Coal Combustion Waste Impoundment

Round 5 - Dam Assessment Report

Winyah Generating Station (Site #004)

Santee Cooper

EXHIBIT 1: SOUTH ASH POND - REPRESENTATIVE SECTIONS OF EMBANKMENT

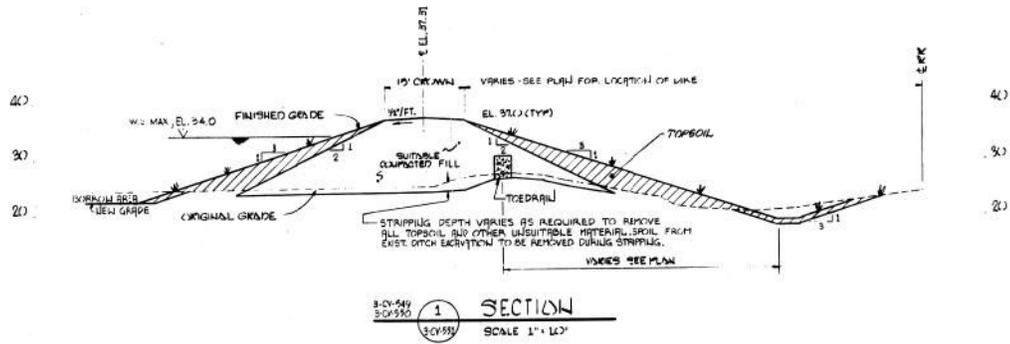
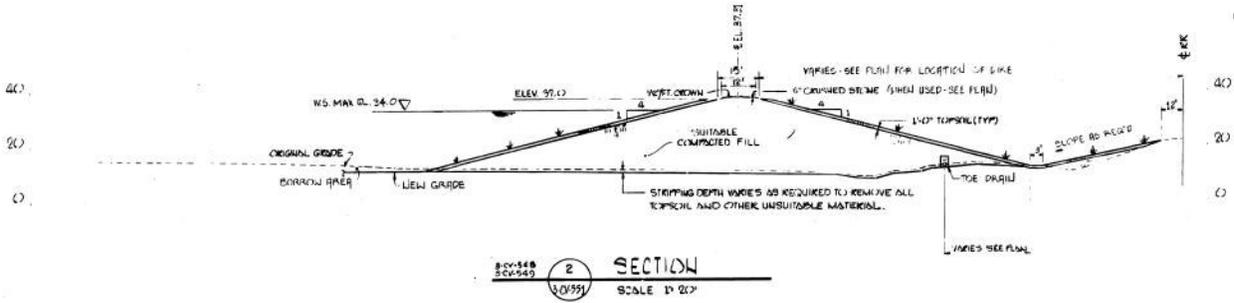
It is recommended that Santee Cooper verify static stability of the South Ash Pond perimeter dike and the West Ash Pond/Unit 3 & 4 Slurry Pond perimeter dike with documented analyses.

It is recommended that Santee Cooper perform an engineering review of foundation soil conditions at the South Ash Pond perimeter dike and the West Ash Pond/Unit 3 & 4 Slurry Pond perimeter dike in greater detail and determine what, if any, limited or detailed analyses of seismic stability and liquefaction potential should be performed.

EXHIBIT 2: UNIT 3 & 4 SLURRY POND AND WEST ASH POND – REPRESENTATIVE SECTIONS OF EMBANKMENT

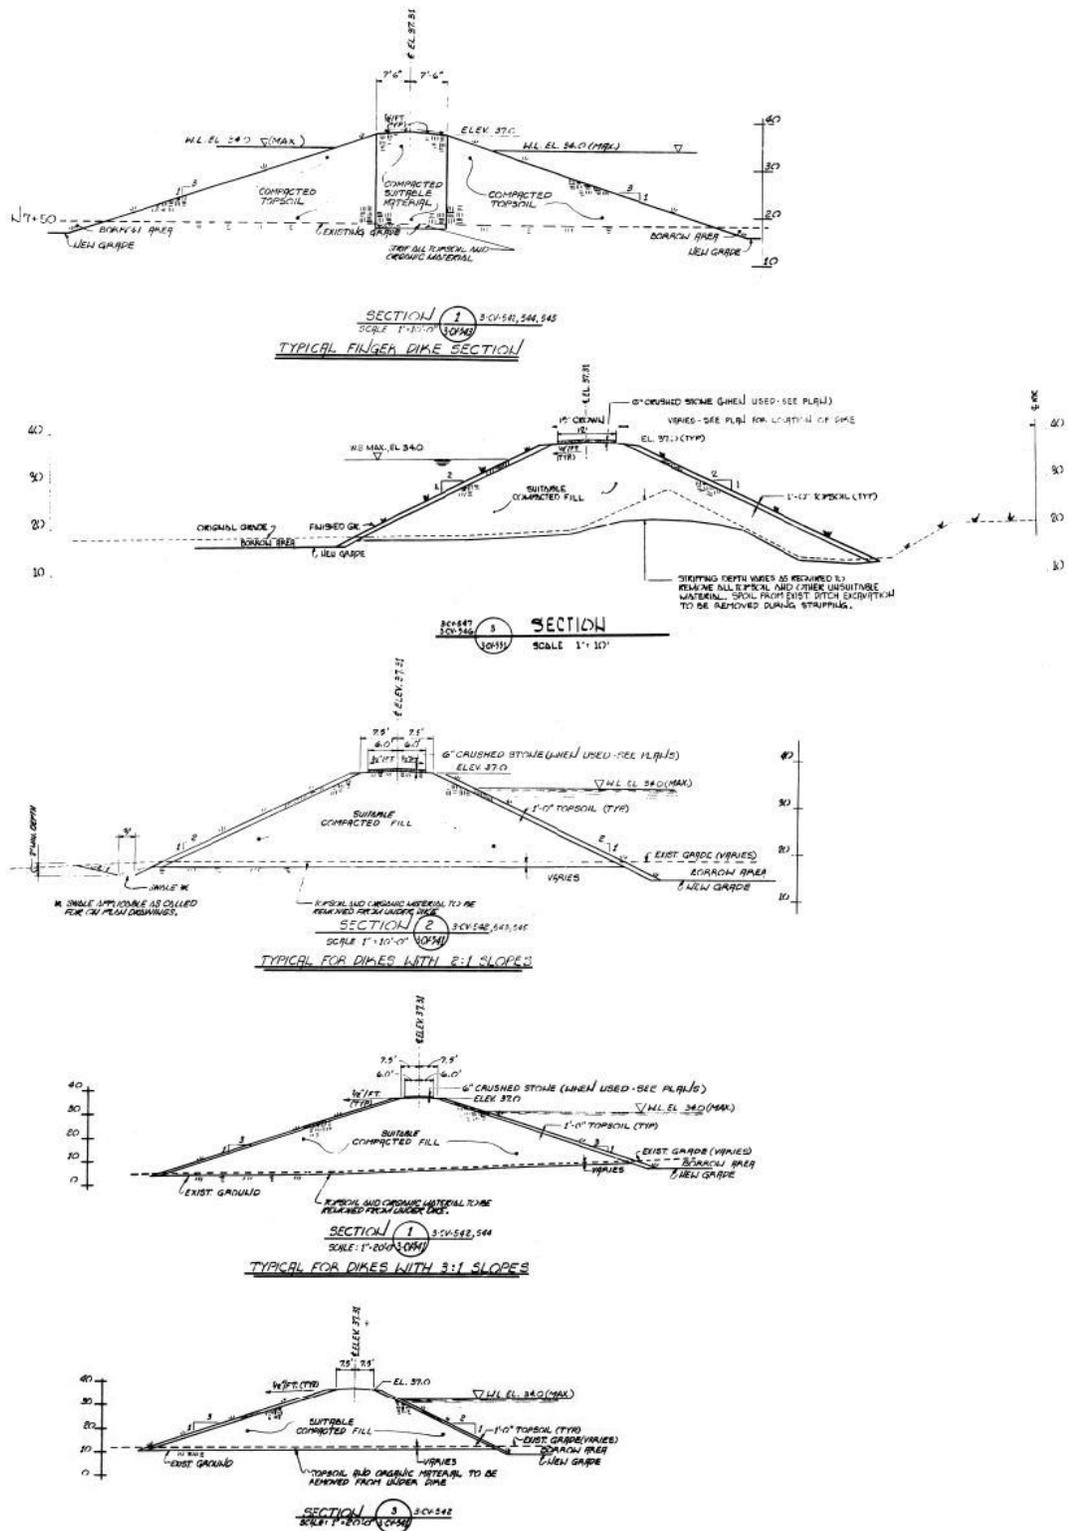
It is recommended that Santee Cooper verify the hydrologic/hydraulic safety of the Unit 3 & 4 Slurry Pond and the West Ash Pond with documented analyses.
